ADDENDUM ONE

Project: **Sullivan County East Middle School Porch Enclosure**

November 7, 2023

FLOOR PLAN - LIGHTING

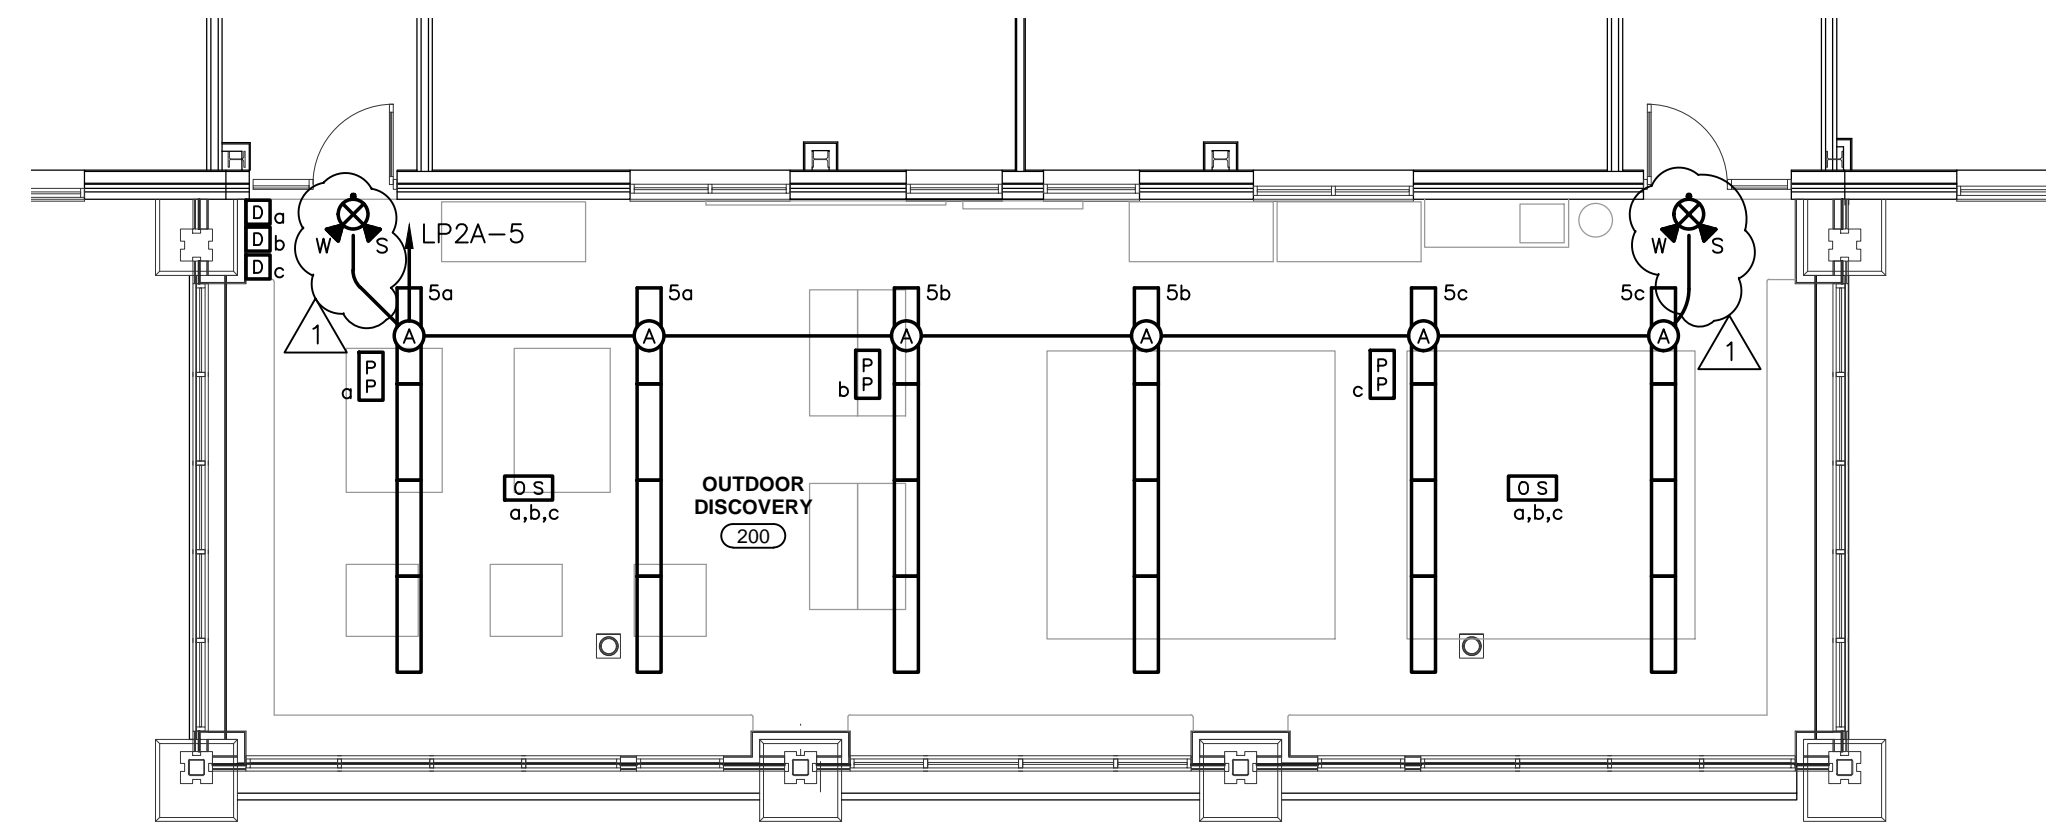
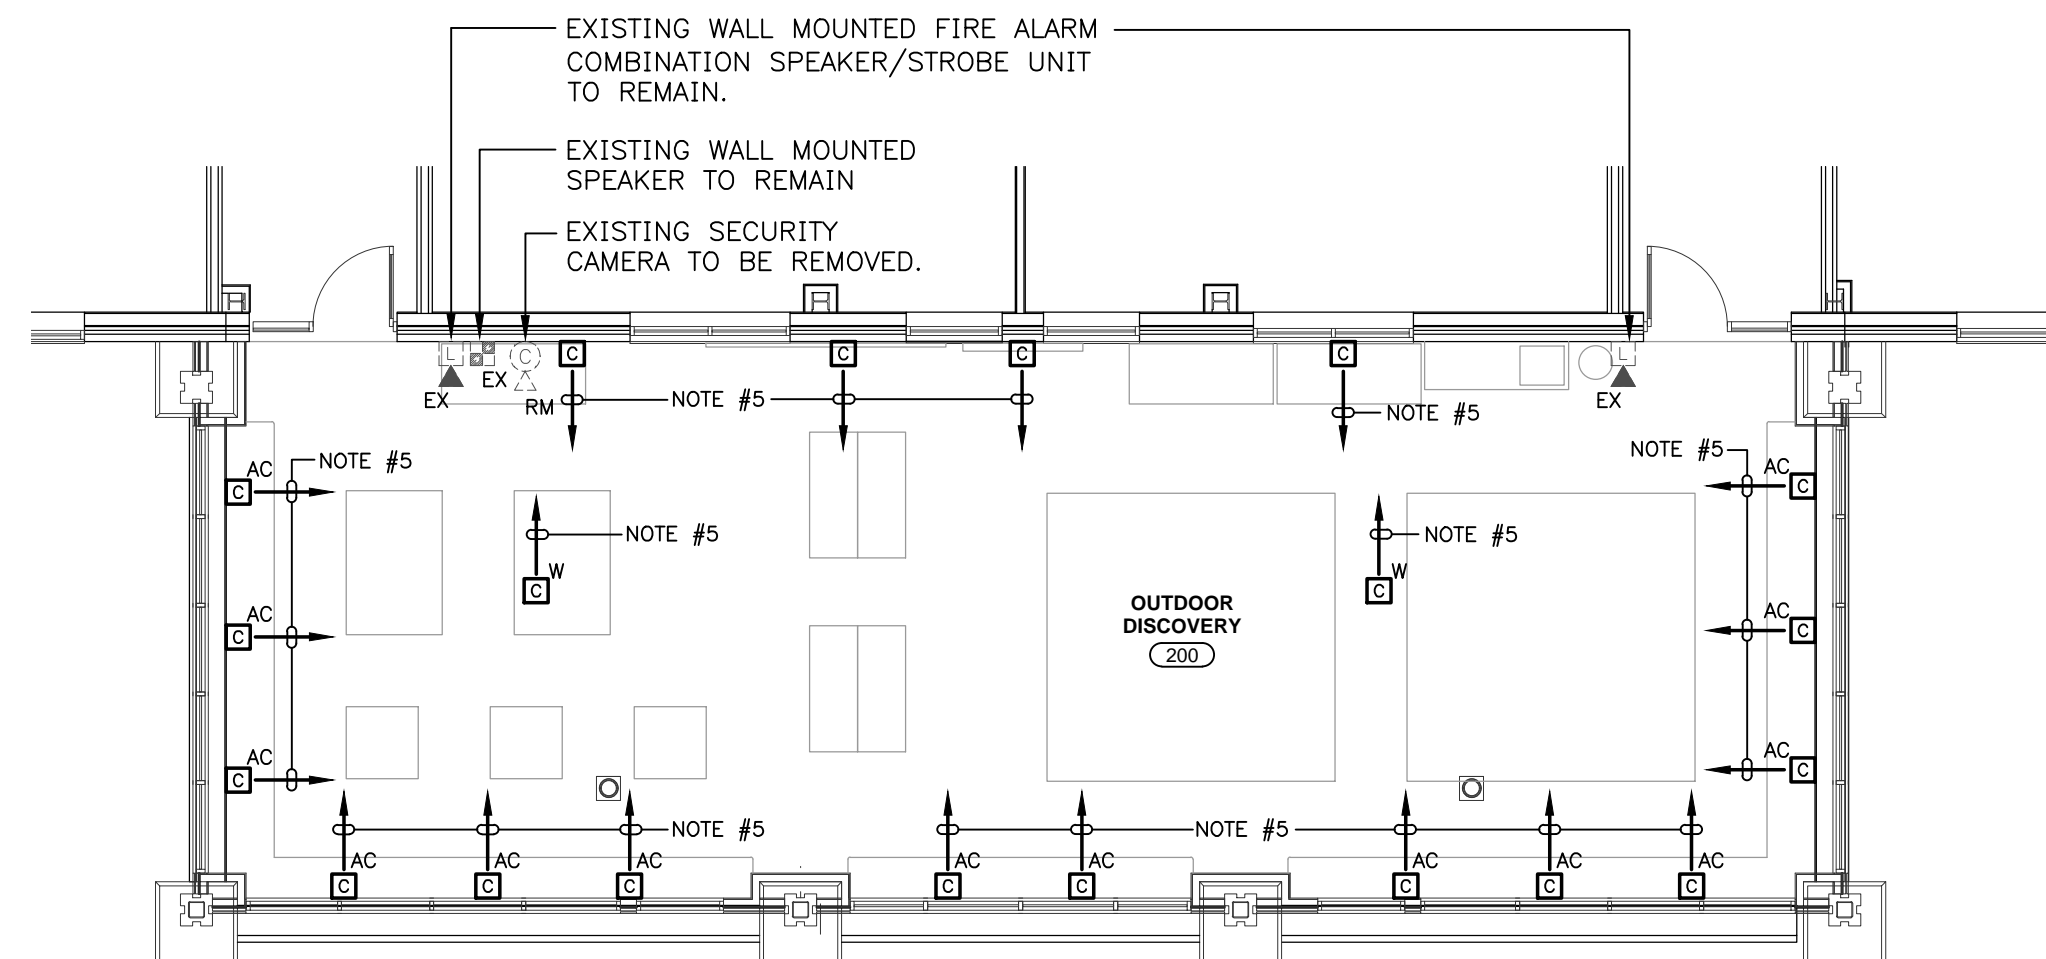
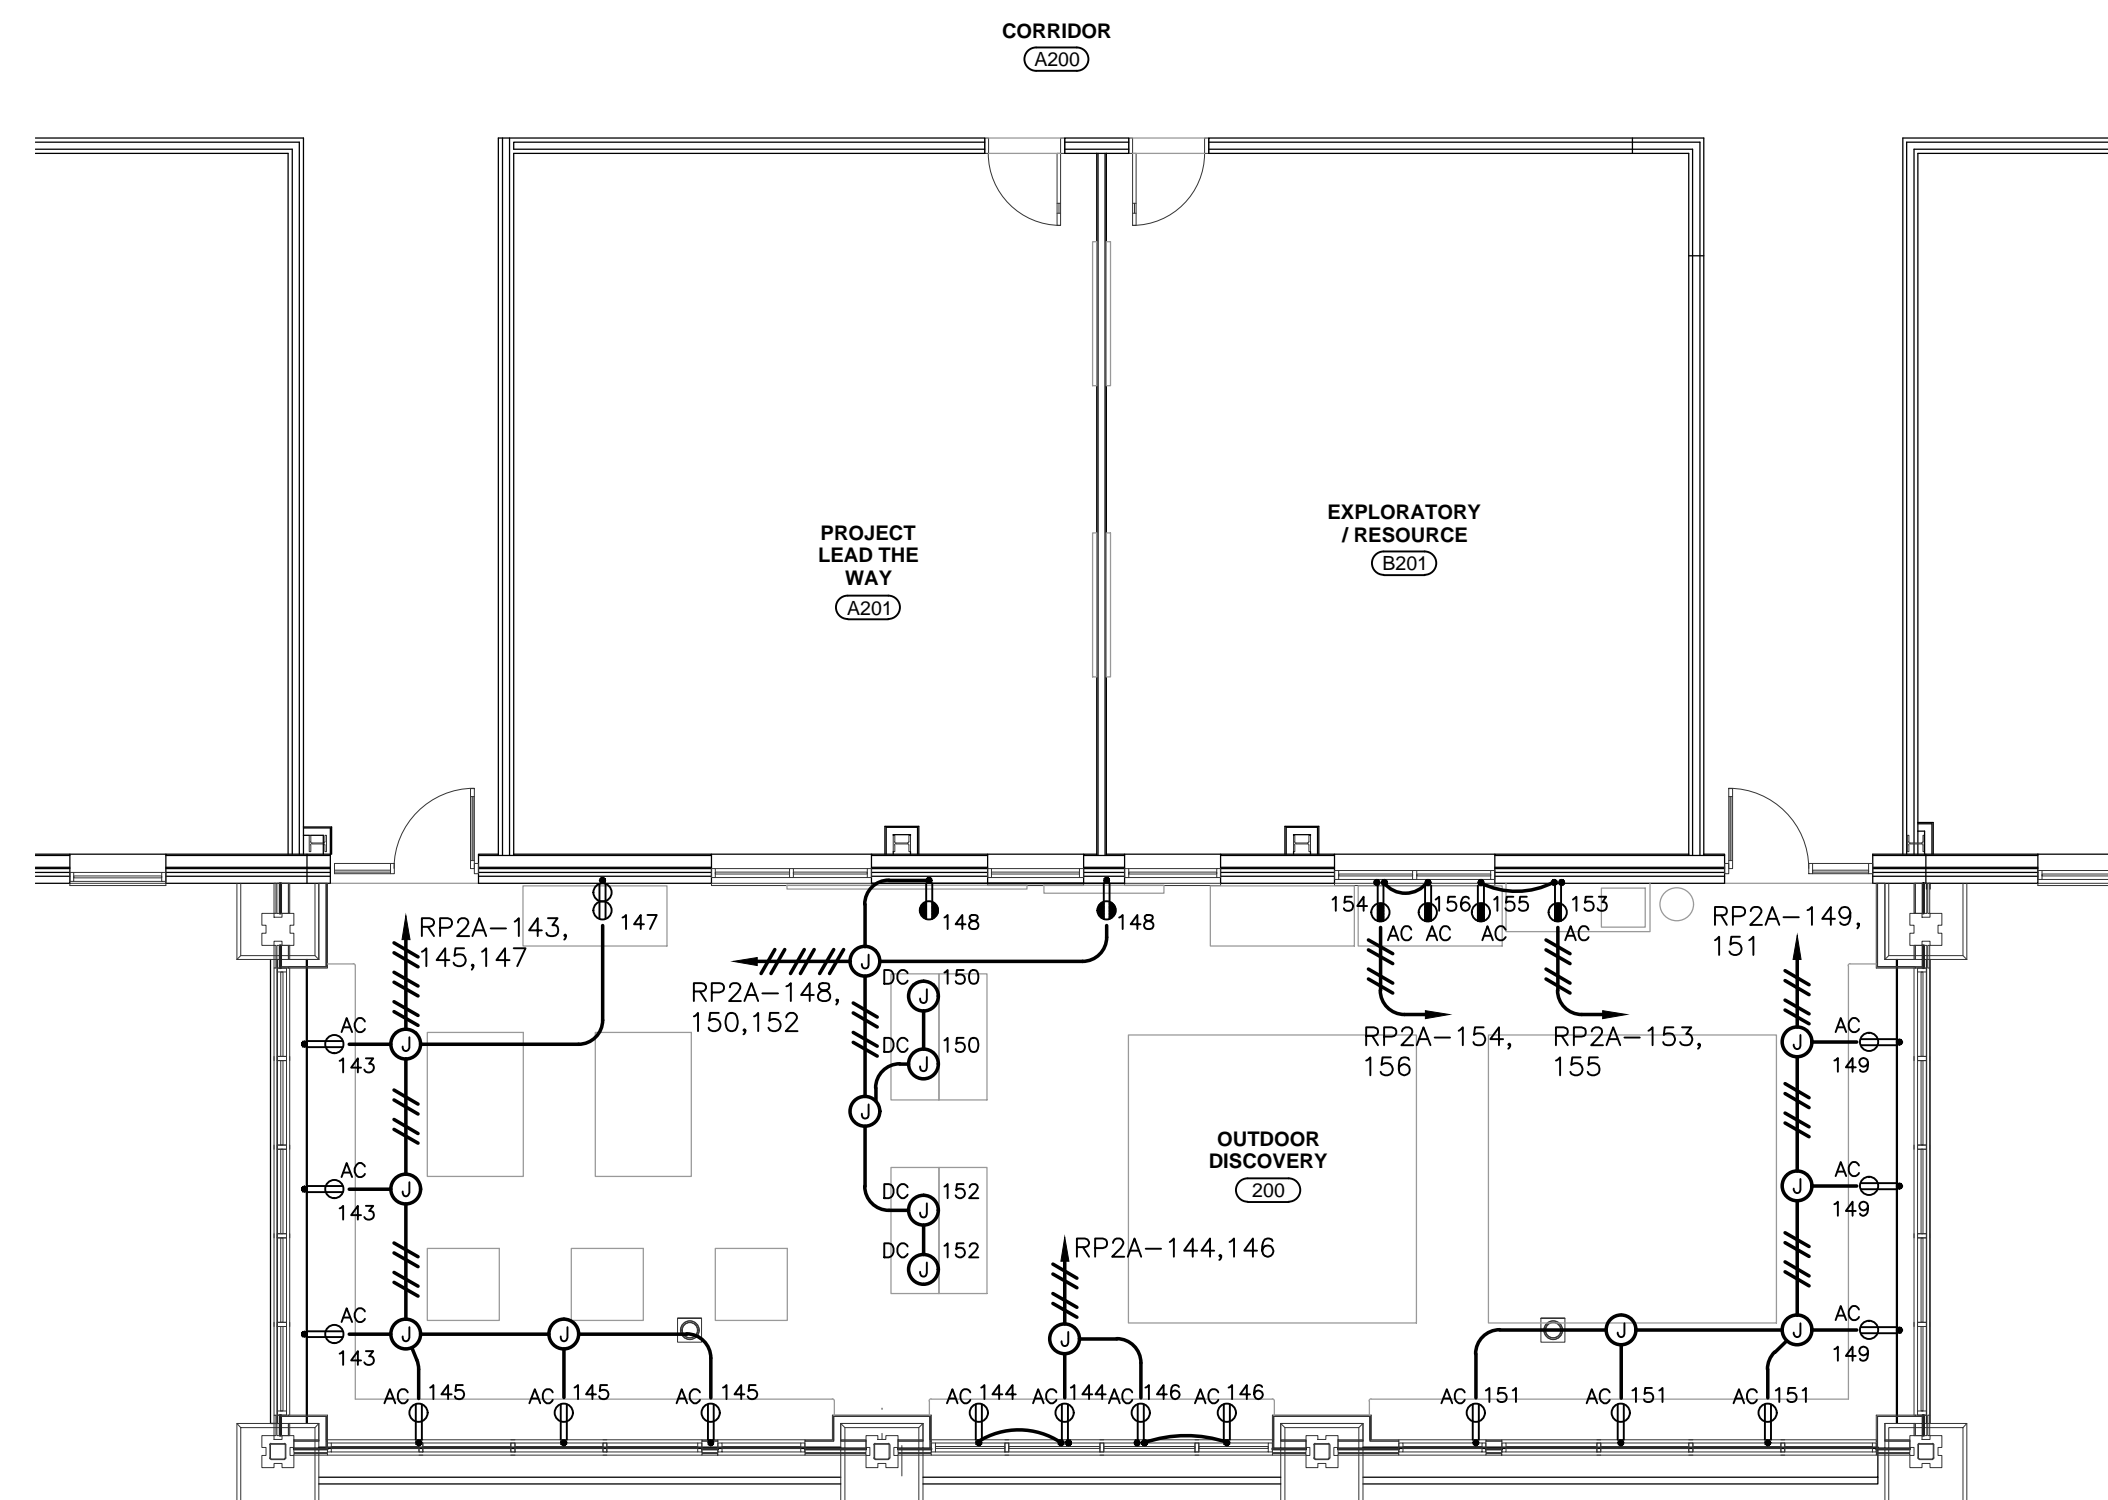
6. **Drawing E-21** has been revised to add emergency egress lighting as requested. Drawing E-01 has also been revised to add the symbol representing the combination exit sign/emergency egress lighting unit to the Legend.
